Road Safety Audit Stage F Part 2

National Roads Authority
Galway City Transport Project
Road Safety Audit Stage F (Part 2)

Issue 2 | 3 September 2015

Figure 4: Proposed junction at Ragoon Road

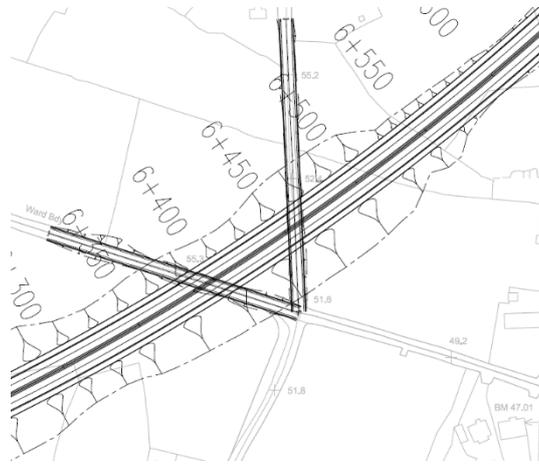
Issue: A crossroad type junction is proposed at Ragoon Road. The Auditors are concerned that junctions of this type can pose a serious collision risk to road users due to the see through issue. This junction may also be complicated due to the reduced visibility from the north as a result of the proposed underbridge. A junction of this type could potentially lead to sudden braking which could result in rear end shunt type collisions or may also lead to side swipe type collisions between passing road users.

Recommendation: The junction type should be changed to a staggered junction.

Problem	To be completed by Designer				Describe Alternative Measure	To be completed by Audit Team Leader	
	Problem Accepted		Recommended Measure Accepted			Alternative Measures Accepted	
	Yes	No	Yes	No		Yes	No
2.11	Y	-	Y	-		✓	
2.12	Y	-	Y	-		✓	
2.13	Y	-	N	-	The transition from single to dual carriageway has been relocated in the Preferred Route Corridor and now occurs at the location of the proposed roundabout at the Ballymoneen Road. This marks the transition from dual to single carriageway. Refer problem 2.6.	✓	
2.14	Y	-	Y	-	During Phase 3 Design, the scheme junction consistency shall be assessed with a view to minimising the number of variations.	✓	
2.15	Y	-	Y	-		✓	
2.16	Y	-	Y	-		✓	
2.17	Y	-	Y	-	During Phase 3 Design the junction layout will be examined and simplified as appropriate.	✓

Figure 5: Proposed N6 Interchange

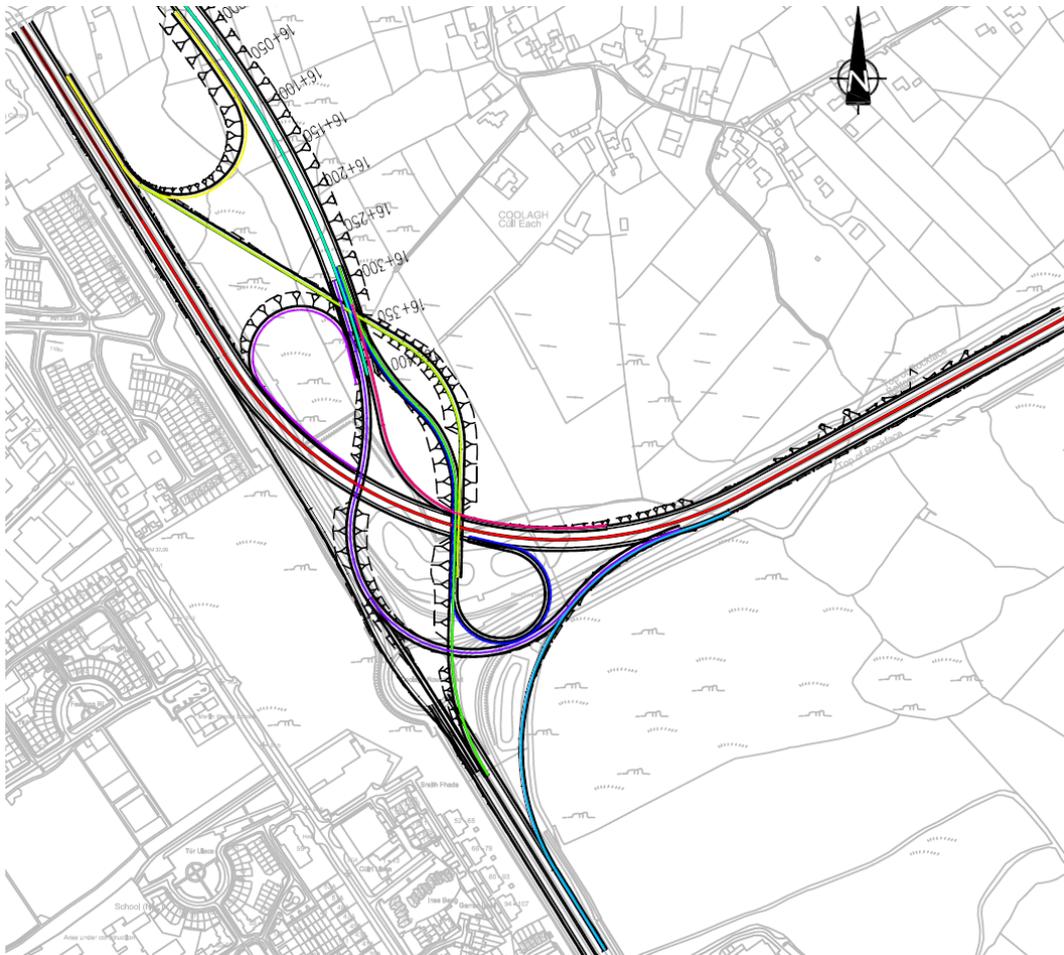
Issue A: The design presented for audit shows the existing N6 at Coolagh being realigned and terminating at the existing signalised junction at Briarhill (see figure 5 – red route). Road users will not expect the N6 to terminate at a signalised junction which could increase the likelihood of rear end shunt type collisions at this location.

Issue B: It is the Auditors opinion that the reduction of the expressway to a single lane in order to join the eastbound N6 (see figure 5 – pink route) could cause a collision hazard as road users will not expect the expressway to reduce to a single lane having travelled unobstructed for ~12km.

Issue C: The merge lane to the N6 westbound from the existing N6 (see figure 5 – yellow route) begins in close proximity to the signalised junction at Briarhill. This could increase the likelihood of rear end shunt or side swipe type collisions on the approach to the merge should a road user attempt to change lanes within the distance available.

Issue D: The merge lane to the N6 eastbound from the existing R446 (see figure 5 – purple loop route) is in close proximity to the expressway merge to the eastbound

N6 (see figure 5 – pink route). Successive merges such as these can pose collision risks to road users on the N6 mainline as well as those joining the N6 mainline.

Issue E: The Auditors are unsure as to how the proposed expressway link to the R446 south, proposed expressway link to the N6 west and proposed N6 at Briarhill to the R446 south (see figure 5 – green, dark blue and lime green routes) will operate as the design includes various lane gains, lane drops and level differences. A combination of all of these factors could prove confusing for road users which could increase the likelihood of collisions throughout the interchange.

Issue F: The design of the R446 northbound merges with the westbound expressway (see figure 5 – purple route) and northbound N6 (see figure 5 – red route) do not appear to have been completed and the merge with the purple route appears to be quite severe and on a curve.

Recommendation: The design of the N6 free flow junction should be readdressed in order to minimise its complexity and to decrease the potential confusion that may be caused to road users.
